TECHNICAL NEWS LETTER

WATER PUMP COMPARISON BETWEEN OLD VERSION AND NEW VERSION

24-1080/ PA1080/ 101080

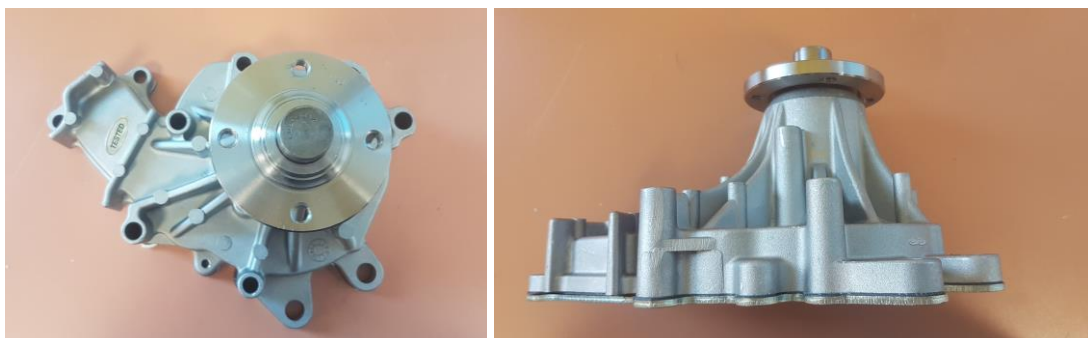
We have modified our water pump ref 24-1080 we have aligned our production as the last OES sample Toyota.

Old version

Old water pump version made in 2 pieces: water pump housing and back-housing.

New Version

New water pump version made in single piece with integrated back-housing.
